**CHARTER TOWNSHIP OF MERIDIAN  
ENVIRONMENTAL COMMISSION  
AGENDA  
Wednesday, July 6, 2016**

Re: Wetland Use Permit #16-03 Application Review  
Towner Road Park  
Charter Township of Meridian

At the request of the Township, FTCH reviewed the Wetland Use Permit (WUP) request, including a Joint Permit Application (JPA), dated May 17, 2016, and prepared by VIRIDIS Design Group.

**EXHIBIT D**  
**BOARDWALK DETAILS**

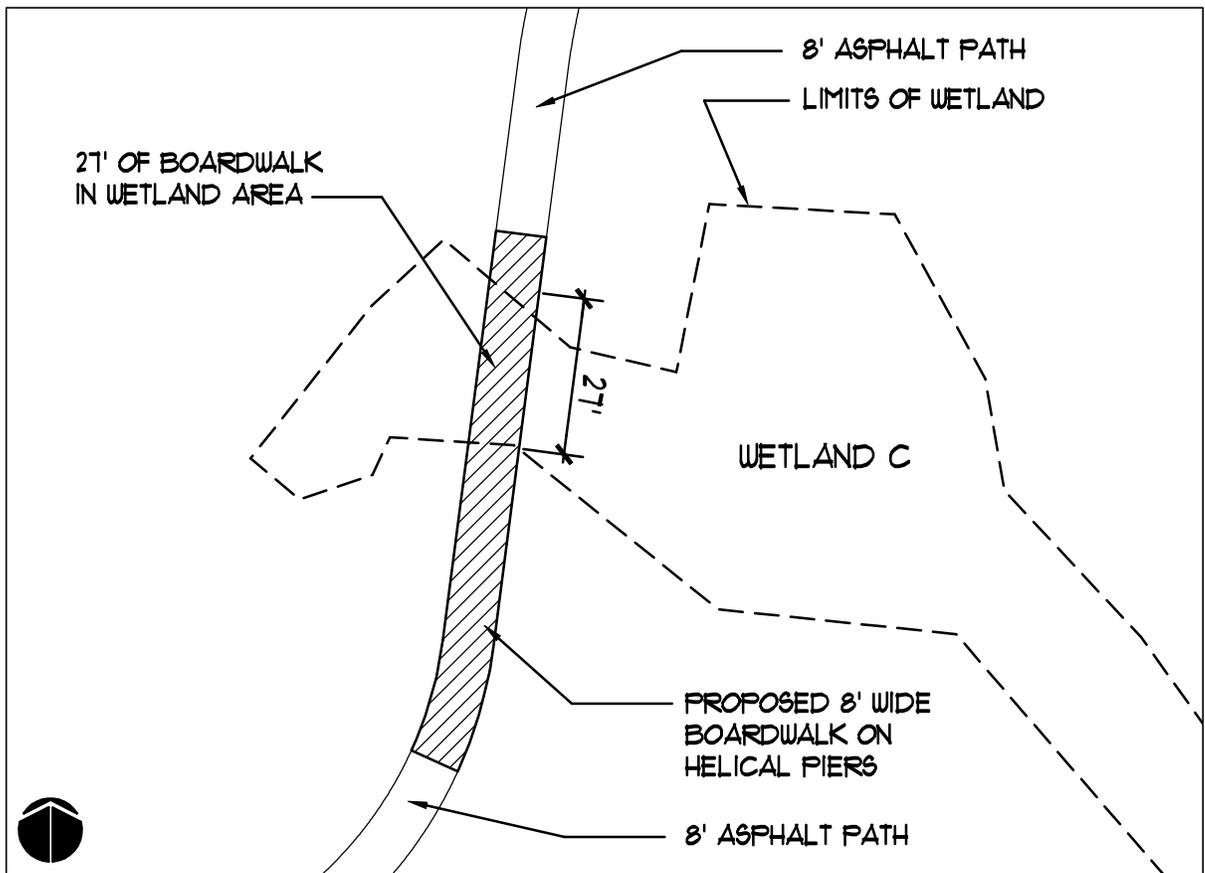
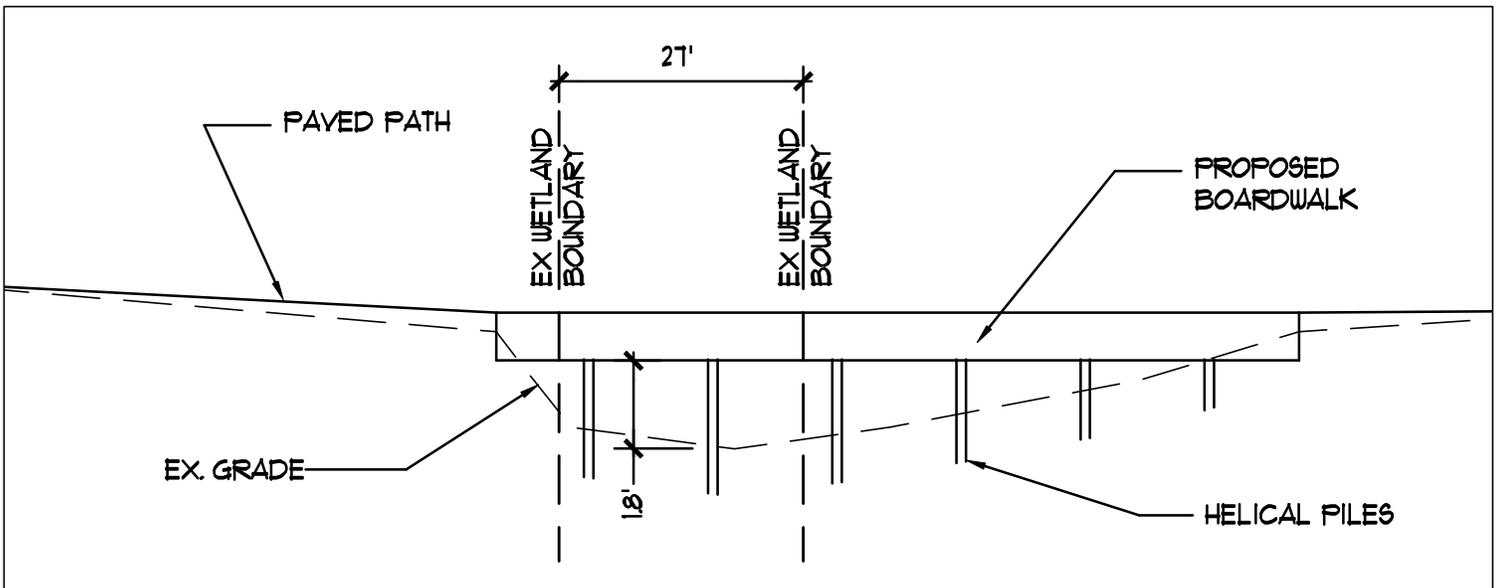
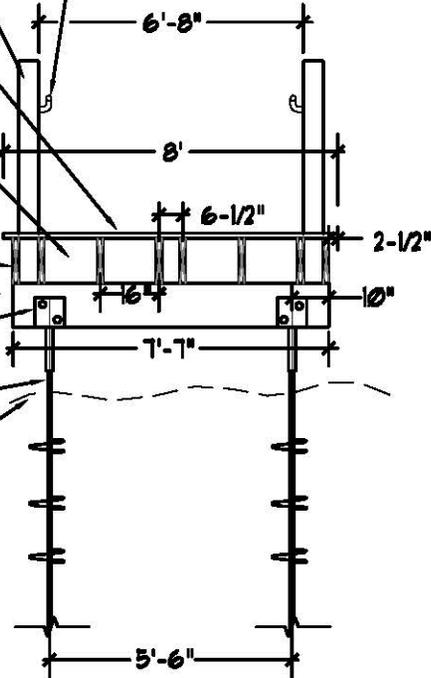
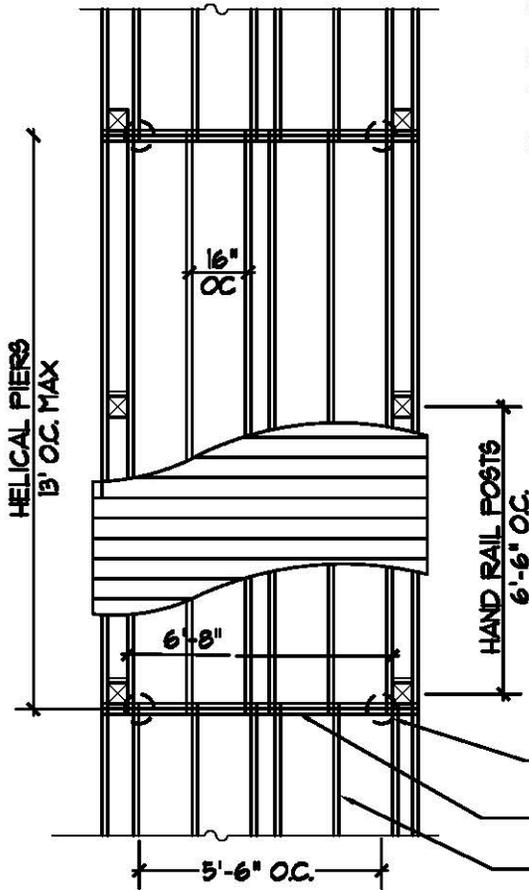
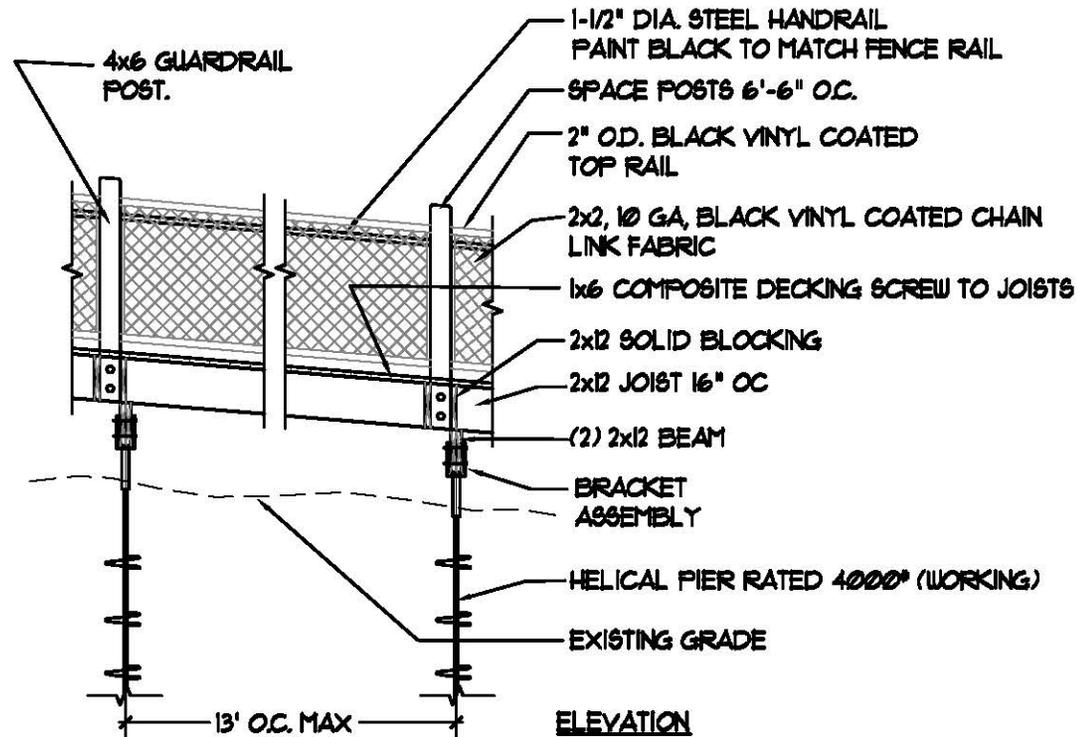
- The size of site wetlands is discussed in the Wetland Impact Overview section. Wetlands C and E are located at the edge of a large wetland complex associated with Lake Lansing. Wetland C appears to have been historically disturbed, due to steep grades at the northern wetland boundary. Wetlands A, C and E are of average quality. Wetland A consists of emergent wetland, while Wetlands C and E contain scrub-shrub wetland.
- The proposed land change has minimal impact upon Wetland C. Based upon the JPA's Exhibit E, it appears the deck of the boardwalk will be high enough to allow growth of herbaceous wetland plants below it. Woody wetland plants will need to be removed to facilitate boardwalk construction.

- Implement appropriate soil erosion and sedimentation control measures during construction to ensure there are no impacts to wetlands outside of project activities as a result of soil erosion.
- Removal of woody vegetation (if present) from the proposed boardwalk area must be accomplished without disturbing the ground surface. Trees and shrubs may not be removed by uprooting them. Cutting tree/shrub trunks near the ground surface and treating the cut end of the stump with an appropriate herbicide to prevent re-sprouting is an acceptable method of plant removal.

**EXHIBIT H**  
**BASIN 3 OVERFLOW DRAINAGE TO WETLAND C**

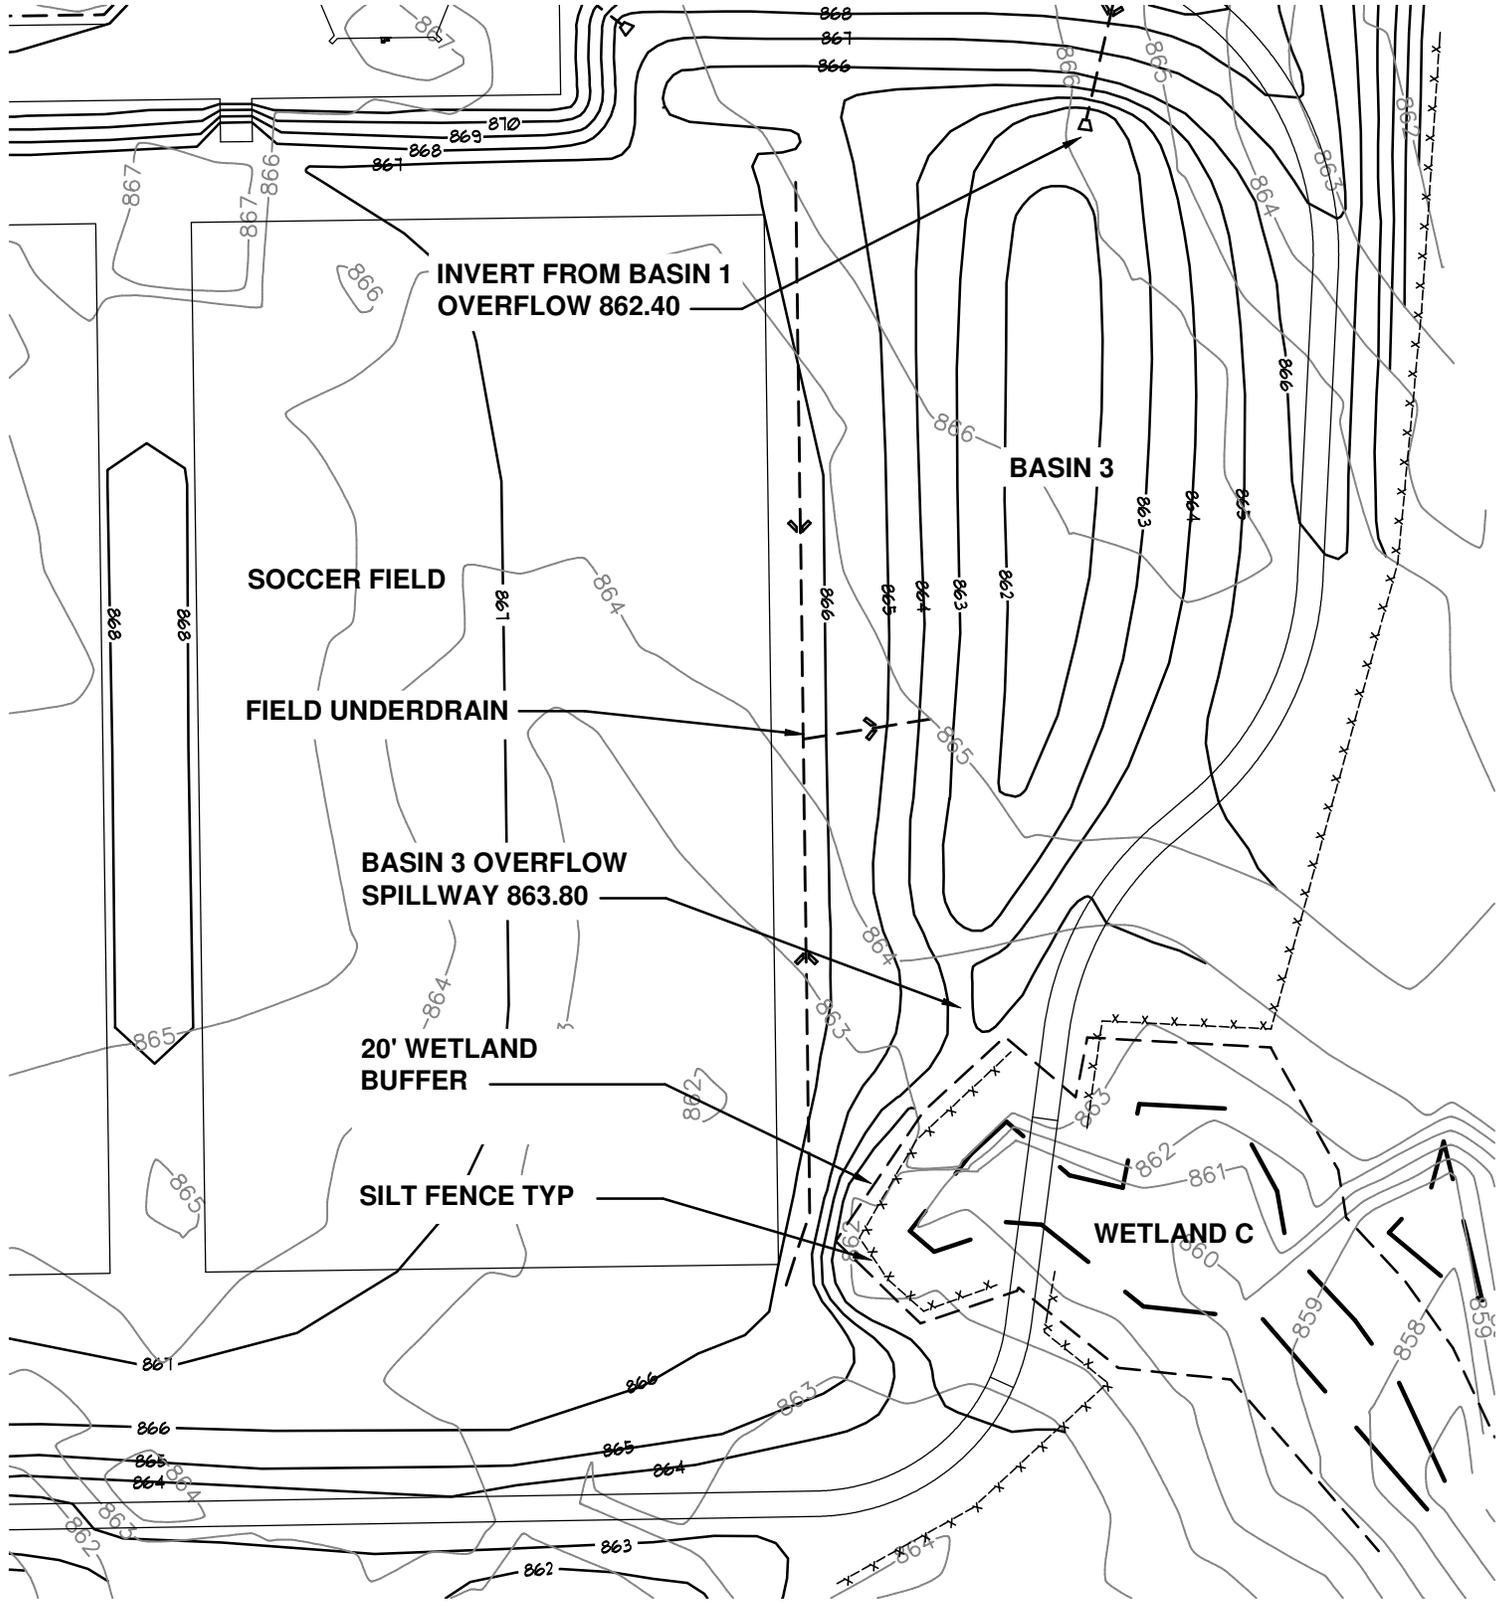
Stormwater discharge points for all three basins are located outside of the 20-foot wetland boundary buffer, as indicated in Exhibits H, I and J. Stormwater drainage to wetlands will not be piped, but is entirely via overflow spillways.

- Exhibits H, I, and J provided in the JPA indicated that silt fence will be installed approximately 20-feet from the wetland boundaries to protect the wetlands from upland soil erosion.
